ADDENDUM 3

DATE: February 15, 2019

Contract 18-C-00041; Stormwater Construction - Citywide FY 18 RE-BID

SW001

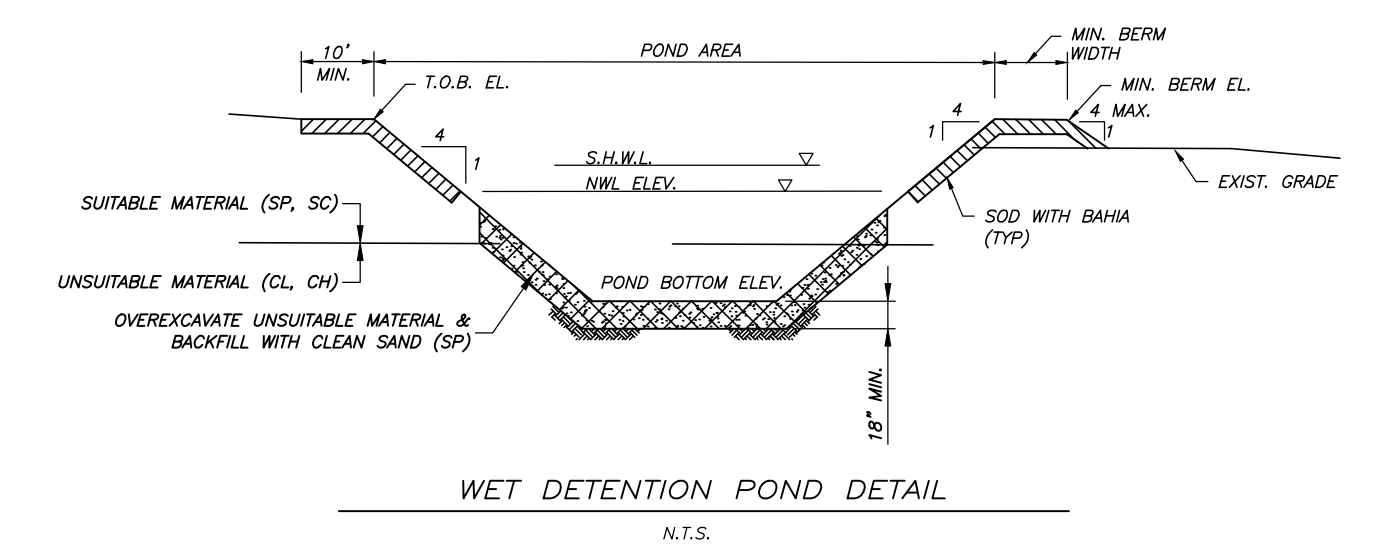
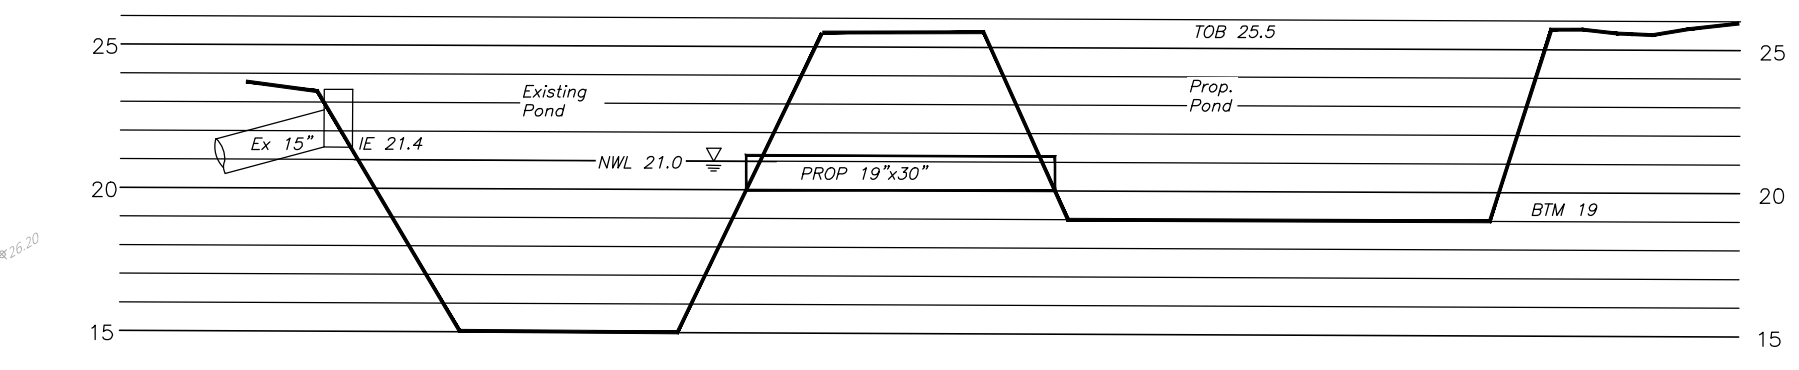
Item 3: Insert the attached David E. West Pond Plan.
